CITY PLANNING COMMISSION

- APPLICATION:
- A. Negative Declaration
 - B. Major Project's Special Permit to develop a fourteen story, 172, 896 square foot office building with parking for 151 vehicles on 12,800 developed square feet in the Central Business District- Special Planning District (C-3) zone.
 - C. Special Permit to decrease required parking from 228 spaces to 151 spaces (34 percent reduction).
 - D. Special Permit to allow attendant parking.
 - E. Variance to encroach in the public right-of-way to construct a subterranean parking garage.

LOCATION: 830 L Street

APPLC. NO. P87-456 MEETING DATE March 10, 1988 ITEM NO 24

SOUTH ELEVATION

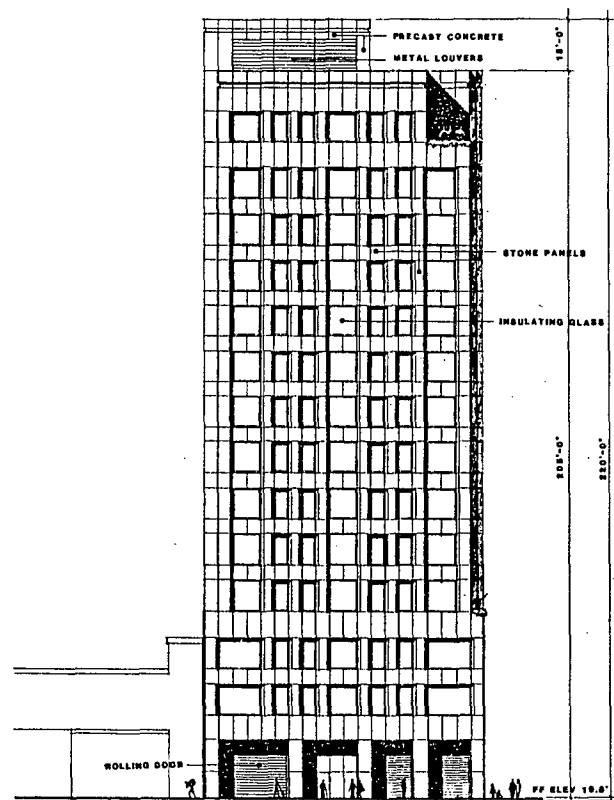
3. an open metal grill pull down door is recommended in the L Street entrance to the parking facility. The interior area of the garage entry visible from the sidewalk shall be finished and painted to match the color of the building exterior; pull down doors facing the alley may be solid rather than open grille work but should be painted to complement the color of the building;

4. materials and design treatment design used on the 9th and L Street facades should also be used on the alley facing facade;
5. the exterior facade of the elevator tower on the west elevation should be enhanced thru a change in surface texture and/or color as suggested in subparagraph 2 above.

L STREET ELEVATION

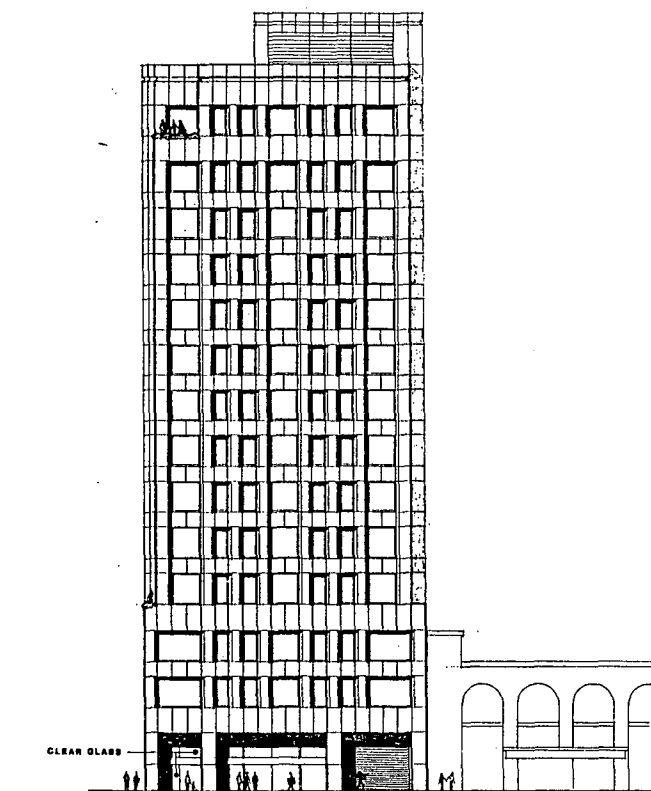
1. enhancement of the building base which enriches the pedestrian experience. This could be achieved through fine-grained detailing and embellishments to the stone surface area columns and entryway. Three dimensional detailing and/or integral art work is highly encouraged. Use of decorative architectural elements such as quality light fixtures, durable and quality door metal hardware, frames and glass, durable awning system or equivalent type of pedestrian protection design feature, decorative sidewalk pavers, architecturally interesting planters and street-tree grille work should also be considered;

2. minimize the bulk and monolithic appearance of the main tower by change in surface texture or color of the stone/precast concrete panels. One suggestion is a combination of polished and flame-cut (rough) granite panels on the vertical and/or horizontal elements of the building rather than using one type texture and materials;
